Sä Dena Hes Mine 2009 Dam Safety Review

Submitted to:
Teck Metals Ltd.
Sä Dena Hes Mine
c/o Bag 2000
Kimberley, BC V1A 2E1

Project Number: 09-1427-0023

Figure 3
Layout of Tailings Management Facility (SRK 2009)

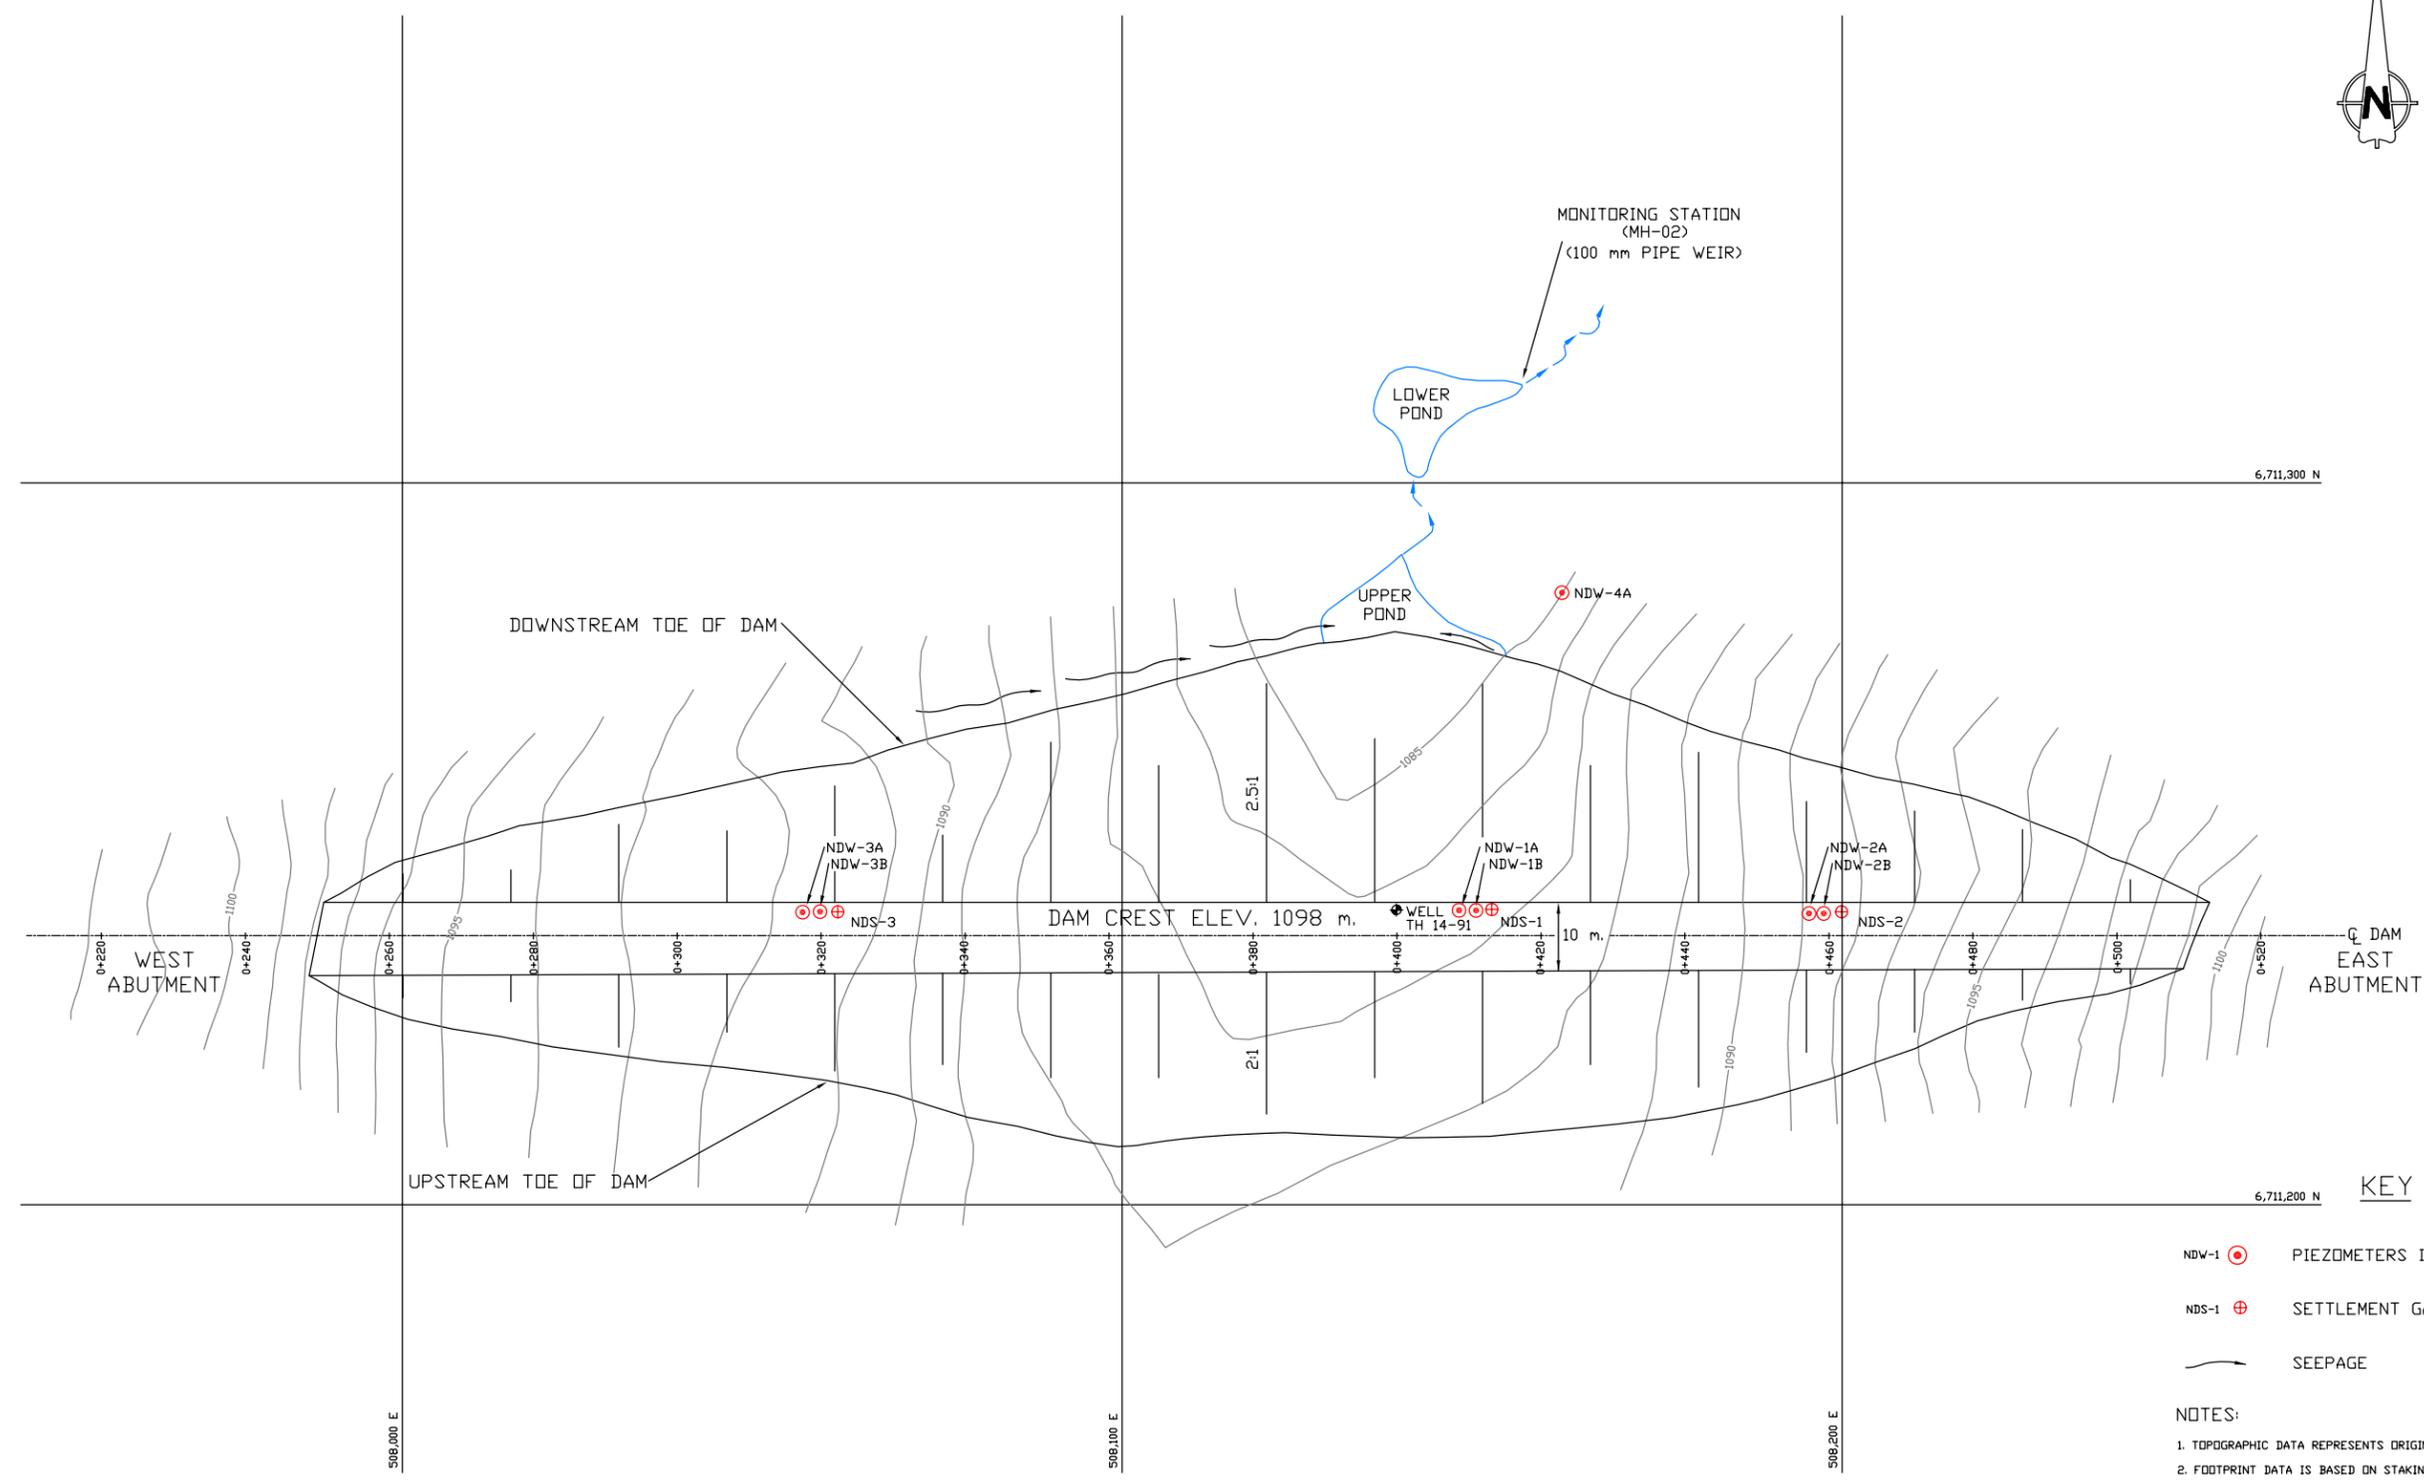
The seepage flow rate from the dam is monitored by a V-notch weir installed at water quality monitoring station MH-07 (Figure 3, and Photo 22). A close inspection of the station revealed that water escapes on the side of the weir, and flow measurement at the V-notch therefore underestimate flow / seepage. Repair to the weir should be made when possible to ensure that all water pass through the V-notch.

- Repair to the weir at water quality monitoring station MH-07 should be made when possible to ensure that all water pass through the V-notch and the seepage flow from the Reclaim Dam are not underestimated.

Figure 8
Reclaim Dam (SRK 2009)

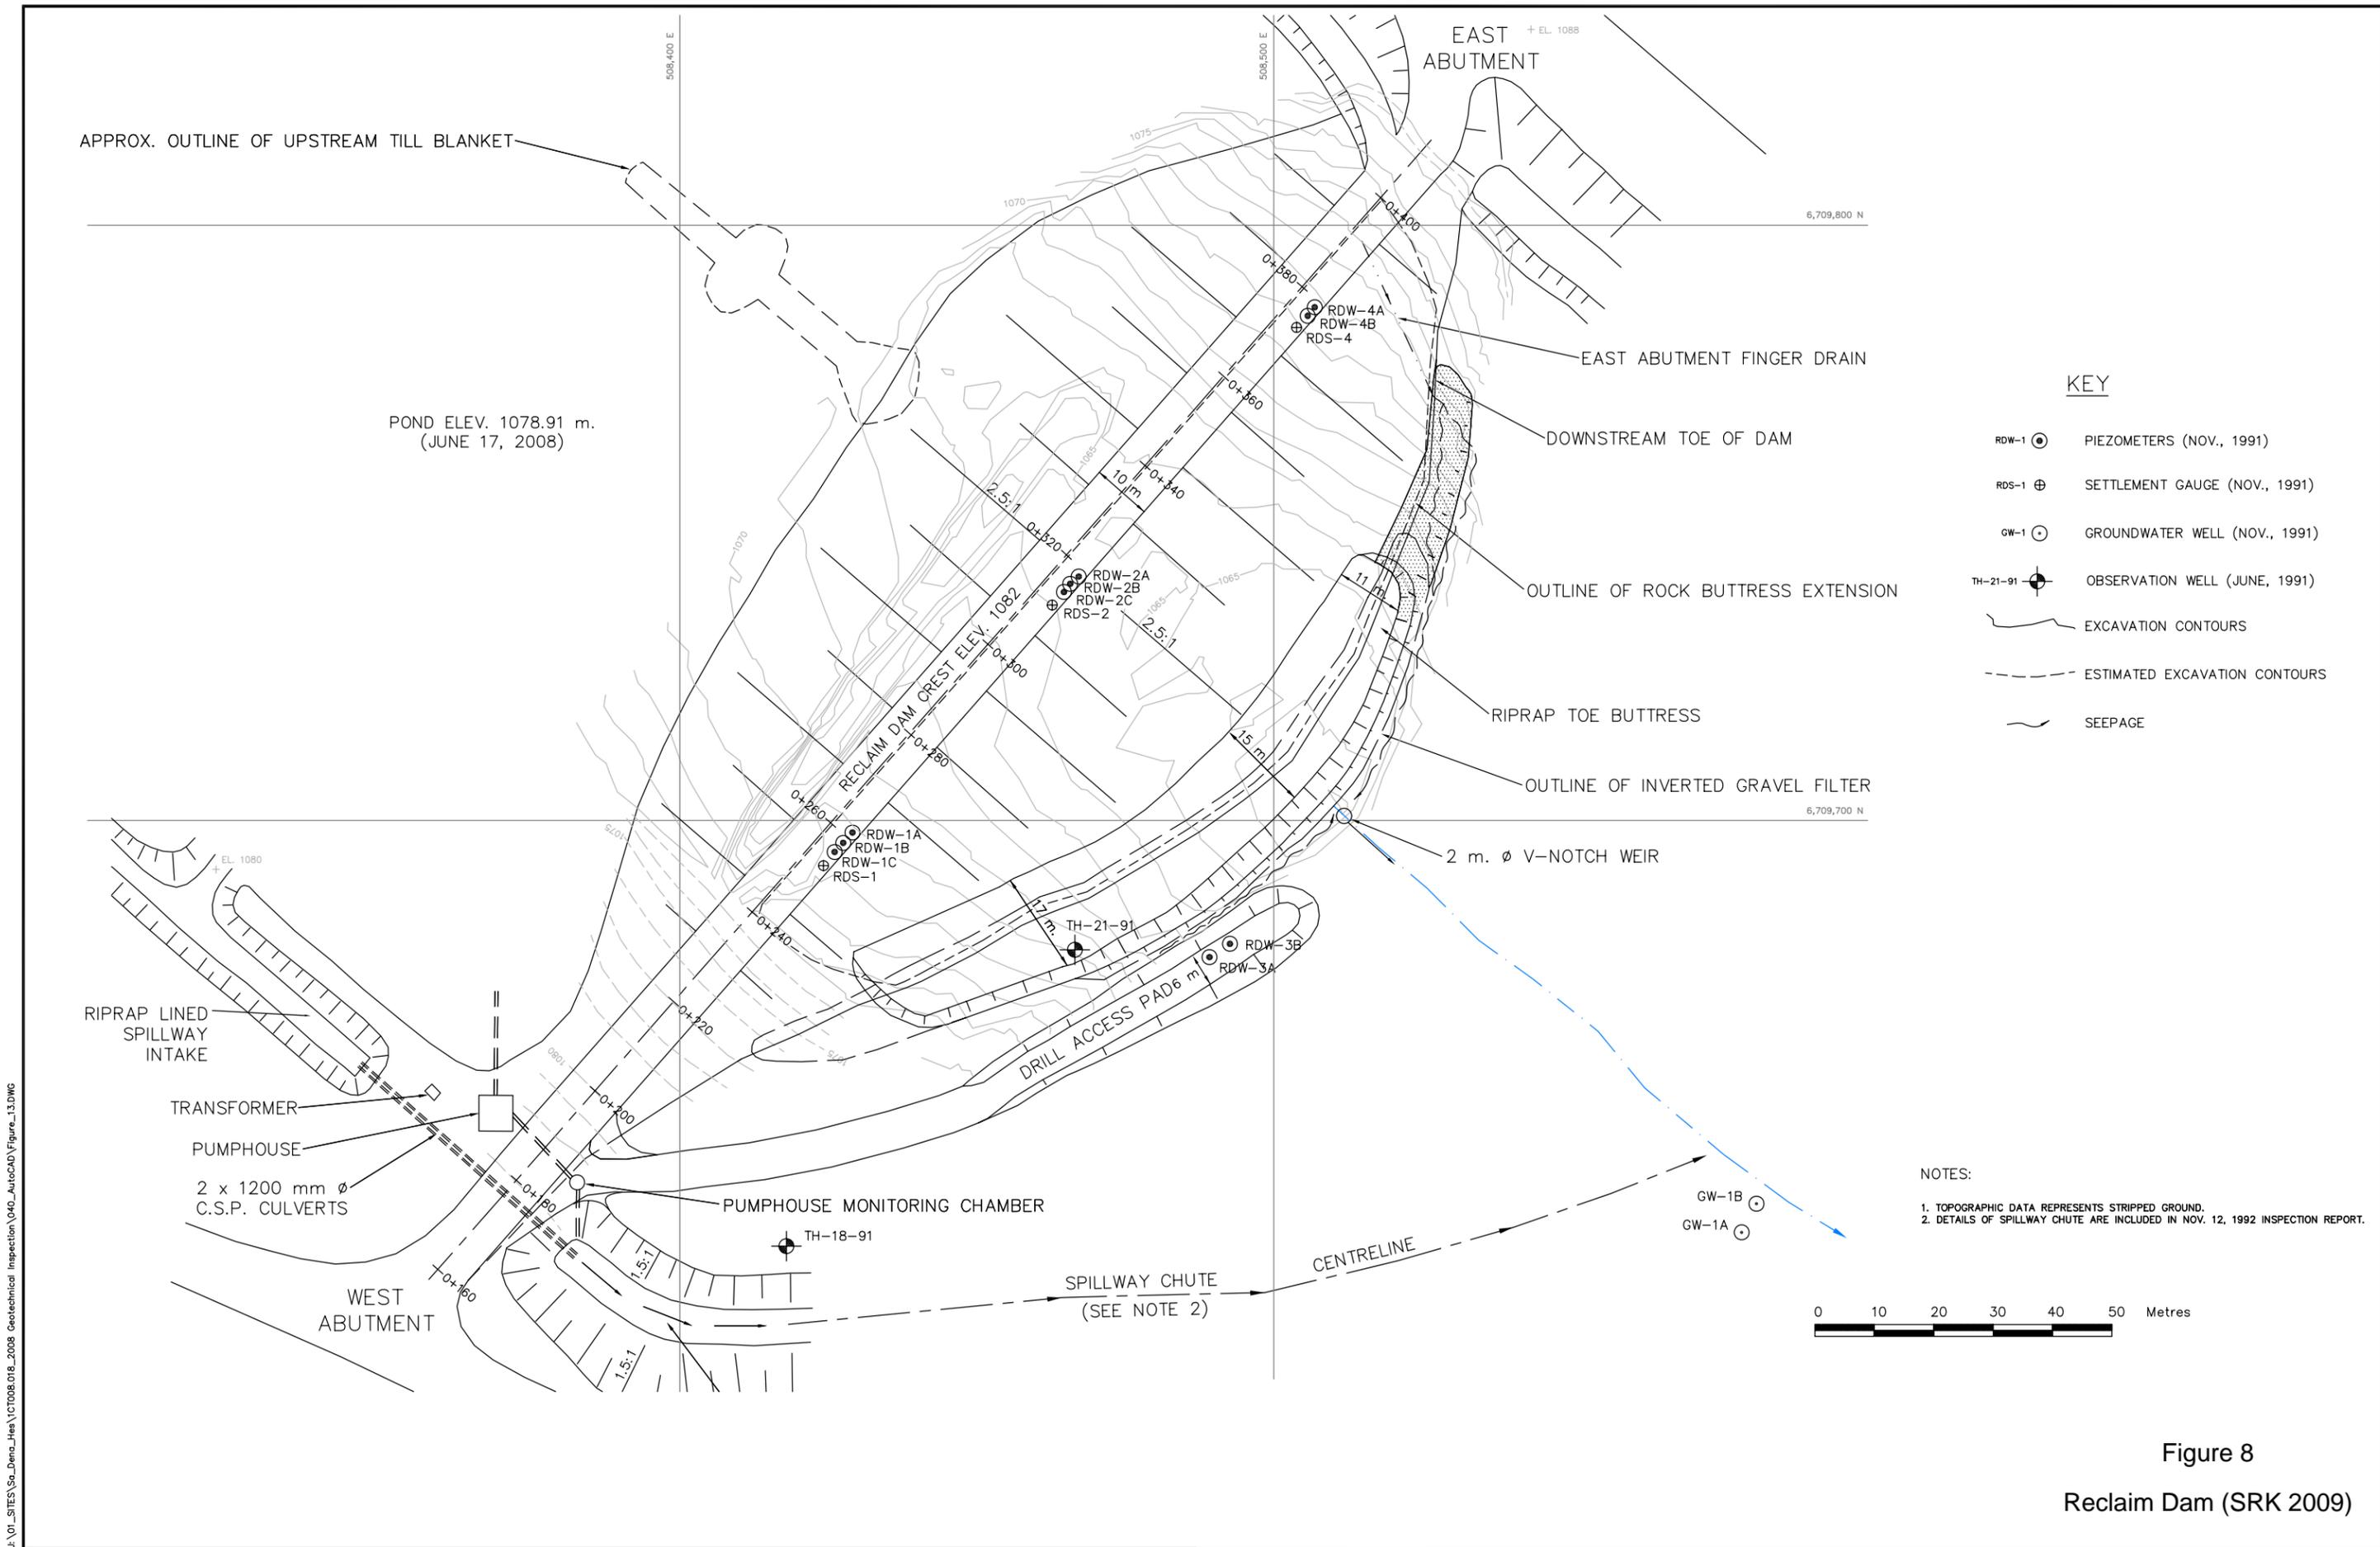
A flood routing analysis, similar to that done for the South Dam Emergency Spillway, should be undertaken to verify the capacity of the Reclaim Dam emergency spillway channel. Inspection of the channel should also be made at regular interval (*e.g.*, during the freshet and before winter) to verify its condition and initiate maintenance as required (*e.g.*, removal of shrubs and trees across the channel).

- Flood routing analysis should be undertaken to verify water levels in the Reclaim Dam emergency spillway channel during 200 year flood event. This analysis is intended to verify if the banks of this channel can be overtopped and eroded during this event. The channel bank height should be increased if overtopping is predicted to occur.
